Project	<b>IEEE 802.16 Broadband Wireless Access Working Group</b> < <a href="http://ieee802.org/16">http://ieee802.org/16</a> >
Title	Correction of Figure D.7
Date Submitted	<b>2006-11-04</b>
Source(s)	Yerang Hur <a href="mailto:yehur@posdata-usa.com">yehur@posdata-usa.com</a> POSDATA Co., Ltd.
Re:	Call for Maintenance Change Requests on IEEE Std 802.16
Abstract	This document suggests correcting Figure D.7 in Annex D.2 Sleep Mode MSCs.
Purpose	Adopt change requests on IEEE 802.16e-2005.
Notice	This document has been prepared to assist IEEE 802.16. It is offered as a basis for discussion and is not binding on the contributing individual(s) or organization(s). The material in this document is subject to change in form and content after further study. The contributor(s) reserve(s) the right to add, amend or withdraw material contained herein.
Release	The contributor grants a free, irrevocable license to the IEEE to incorporate material contained in this contribution, and any modifications thereof, in the creation of an IEEE Standards publication; to copyright in the IEEE's name any IEEE Standards publication even though it may include portions of this contribution; and at the IEEE's

Figure D.7 Example sleep mode - MS initiated [for the case of TRF\\_IND required =1 and Traffic\\_triggering\\_wakening\\_flag = 1](#)

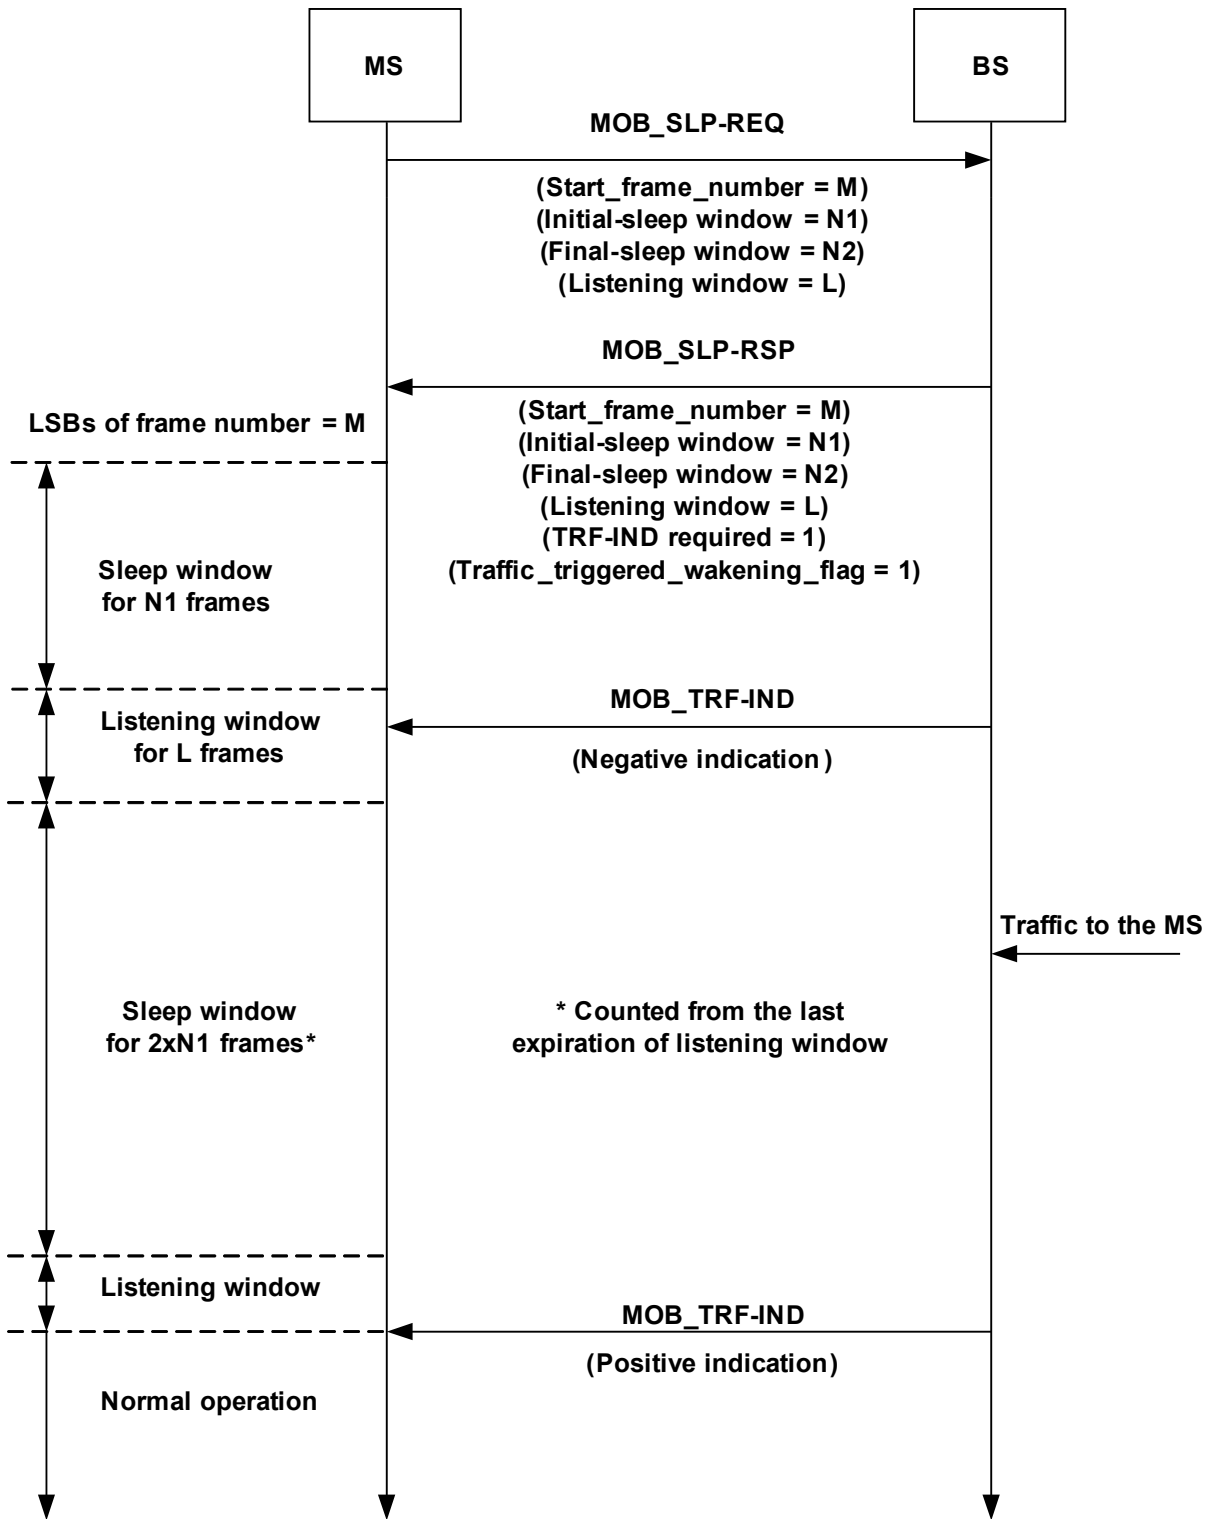
These editorial corrections are required In Figure D.7 of Annex D.2.

- a. Min-sleeping interval and Max-sleeping interval are not defined in sleep mode operation. Those should be Initial-sleep window and Final-sleep window, respectively.
- b. Two notations L' and L1 are used for the Listening interval. It should be L1 in the figure.
- c. Description on the starting point of sleep window is not consistent with description in 6.3.21.2. The size of sleep window should be counted from the last expiration of listening window according to 6.3.21.2 and Figure 130a.

[Adopt a revised figure in the next page as Figure D.7:]
